JOINT REGIONAL PLANNING PANEL (Sydney East Region)

JRPP No	2015SYE073
DA Number	DA-171/2015
Local Government Area	Canterbury City Council
Proposed Development	Demolition of existing structures and construction of a mixed use development comprising three towers (6 to 8 storeys) above a podium containing 110 residential units, ground level commercial and basement parking
Street Address	1188-1202 Canterbury Road, Roselands
Applicant/Owner	Urban Link Pty Ltd
Number of Submissions	Original application – 9 individual submissions and 3 petitions Amended application – 5 individual submissions and 2 petitions
Regional Development Criteria (Schedule 4A of the Act)	The application has a capital investment value in excess of \$20 million and is referred to the Join Regional Planning Panel (Sydney East Region) for determination.
List of All Relevant s79C(1)(a) Matters	<ul style="list-style-type: none"> • State Environmental Planning Policy 55 – Contaminated Land (SEPP 55) • State Environmental Planning Policy 65 – Design Quality of Residential Apartment Development (SEPP 65) • State Environmental Planning Policy (Infrastructure) 2007 (SEPP 2007) • State Environmental Planning Policy 2004 (Buil

Figure 5 – Shadow diagram at 9.00am 21 June

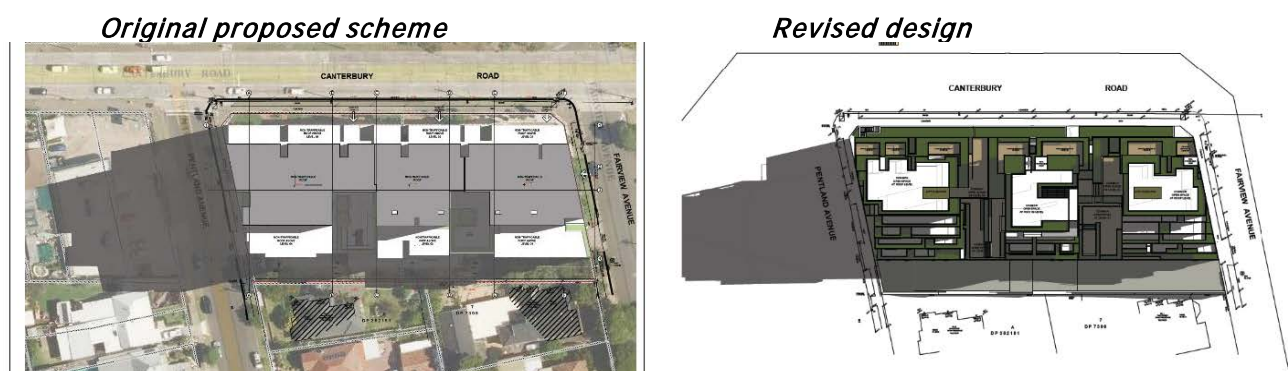
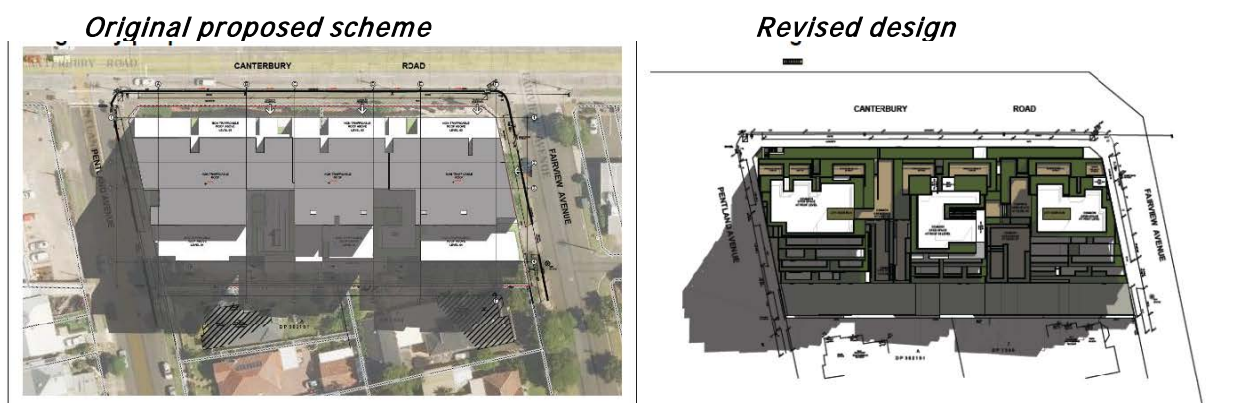
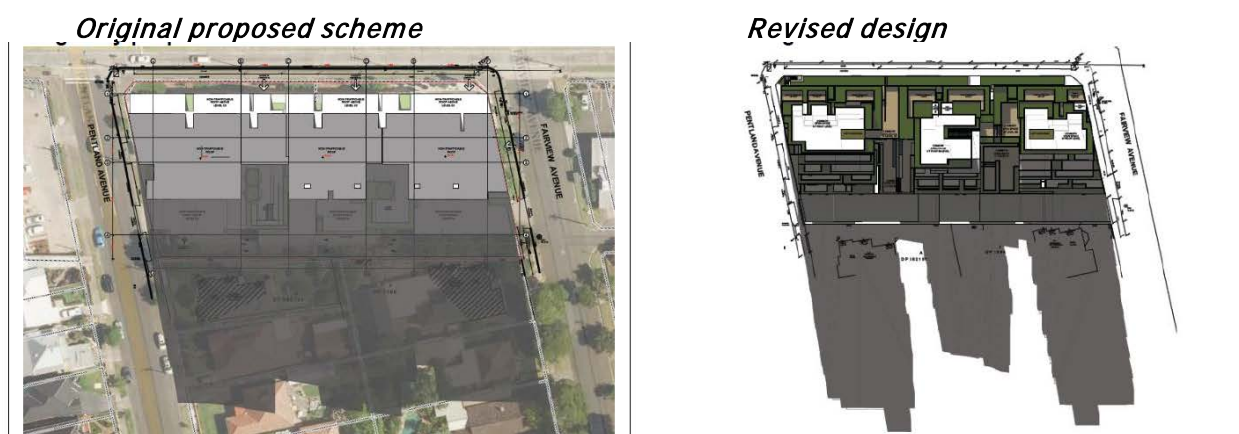
The excess height consists of 2 floors on the top of the eastern and western towers which effectively raises their height from 6 to 8 levels. The other component of the height excess is the 3-metre-high lift overrun and fire stair access centred on the roof of all three towers that would not generally be visible from street level.

The development has been redesigned to respond to concerns of inappropriate built form. The initial application consisted of 120 apartments in a single block and not recessed away from the boundary or podium level. This proposal, while generally compliant with the 18m height level, resulted in complete overshadowing to properties to the south of the site and resulted in a large number of the apartments not meeting the minimum solar requirements. A comparison of the shadows cast by the original scheme versus the current proposal is shown in Figures 5-7 below.

Figure 10 – Close up of the proposed rear laneway within the 9m rear setback

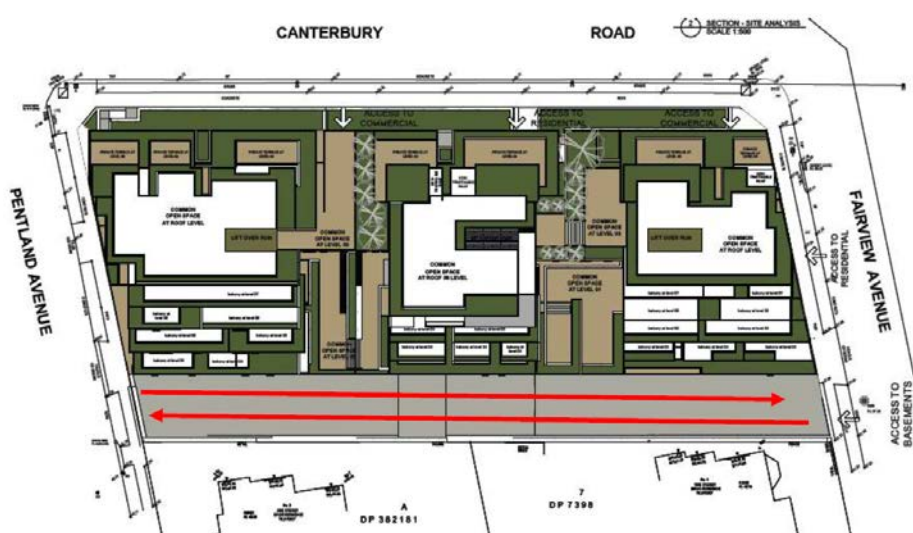
The application involves the construction of a 9-metre-wide 2-way laneway with pedestrian walkway and landscaping strip at the rear of the property that will provide vehicular access to the site. The laneway would extend from Fairview Avenue in the east to Pentland Avenue in the west providing a through site link for both pedestrians and vehicles. The design and location of the laneway is similar to existing laneways to the rear of Canterbury Road (refer to Figure 9) and meets the objectives of Council's resolution dated 28 August 2014 which strongly encourages the provision of rear lane access on major corridor routes (such as Canterbury Road) to provide access to developments in order to minimize traffic impacts.

Council's Traffic Engineers have advised additional detail is required in relation to the design of the laneway and vehicular access to the site. These details will be required as a deferred commencement condition.

- 2) The proposed nine-metre-wide lane shown on drawing number A3101 dated 20/04/16 must be designed to comply with current standards to the satisfaction of the Director City Works. The design must be lodged with Council for determination. The designer must have regard to the following:

- f) The laneway is to comprise of two travel lanes in a carriageway of 6000 mm wide measured kerb face to kerb face and provide for two-way traffic flow.
